DESCRIPTIVE REPORT

Type of Survey HYDROGRAPHIC
Field No. RA-40-01-02
Registry No. H11021

Descriptive Report to Accompany Hydrographic Survey H11021

Project OPR-P182-RA-02
Southwest Alaska Peninsula, Alaska
Scale 1:40,000
June - August 2002
NOAA Ship RAINIER
Chief of Party: Captain James C. Gardner, NOAA

Figure 1. H11021 Survey Limits.

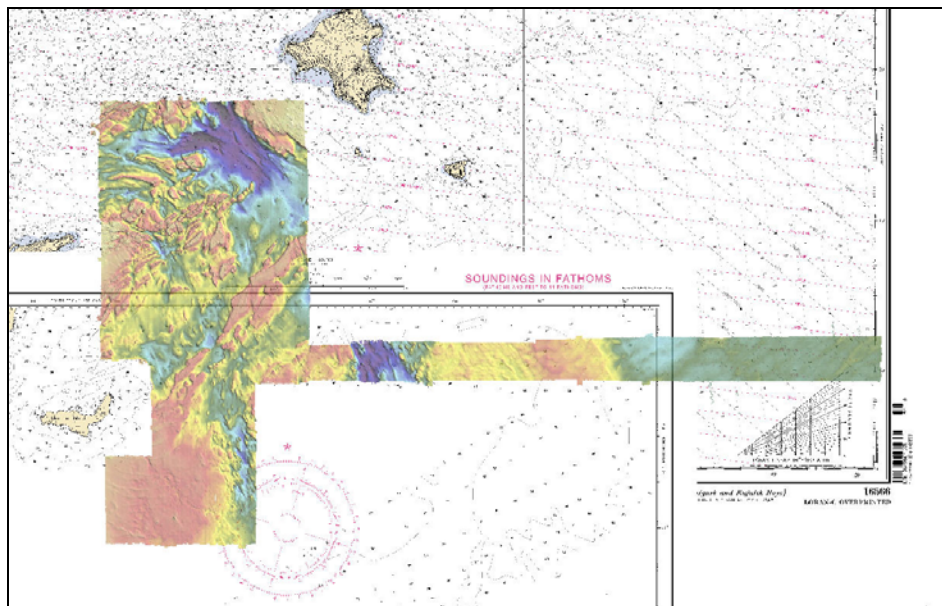
Data acquisition was conducted from June 6 to August 1, 2002 (DN 157 to 213). Due³ time constraints sheet H11021 survey AM was not completed. The South East portion of sheet AM remains unsurveyed and due to the complexity of the area the hydrographer recommends the area be surveyed.⁴

⁴ Concur. Complete survey as resources allow.

Figure 2. H11021 Junctions.

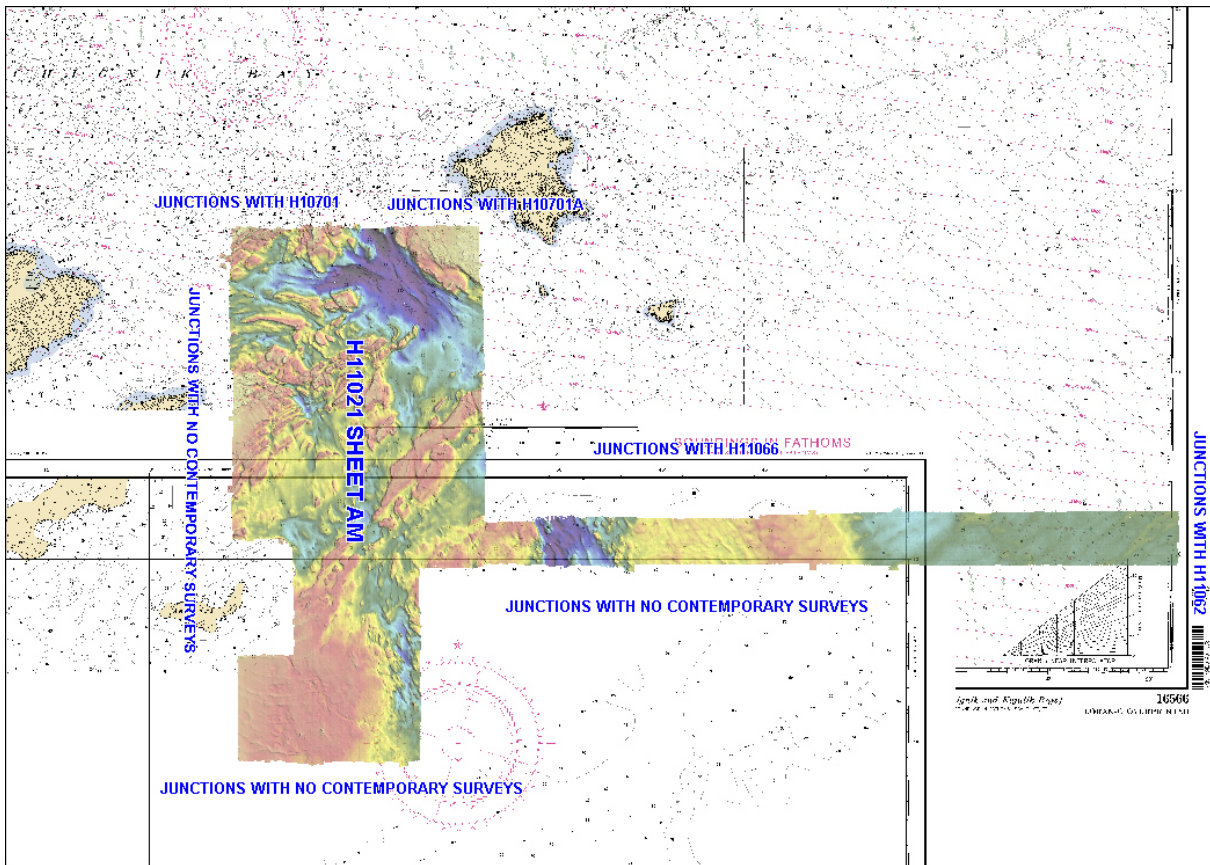
The following contemporary survey junctions with H11021 (see Figure 2.):

<u>Registry #</u>	<u>Scale</u>	<u>Date</u>	<u>Junction side</u>
H11062	1:10,000	2002	North West
H11066	1:40,000	2001	West
H10701	1:20,000	1996	North
H10701A	1:20,000	1997	North

Surveys H1062, H1066 junction well with this survey, a cursory comparison indicates differences are generally less than one fathom. A junction comparison was not completed with sheets H11071 and H11071A. Copies of these data were not provided with the project instructions.

Final comparisons will be made at the Pacific Hydrographic Branch (PHB) after the application of smooth tides.¹⁰

¹⁰ Junction comparisons were made during office processing. A few depths were transferred in color to the present survey to provide a more complete portrayal of depth curves within the common areas. Multibeam data within the common areas of H10701 and H10701a provided a better depiction of the bottom. Standard depth curves have been shown on the present survey in consideration for these datasets.
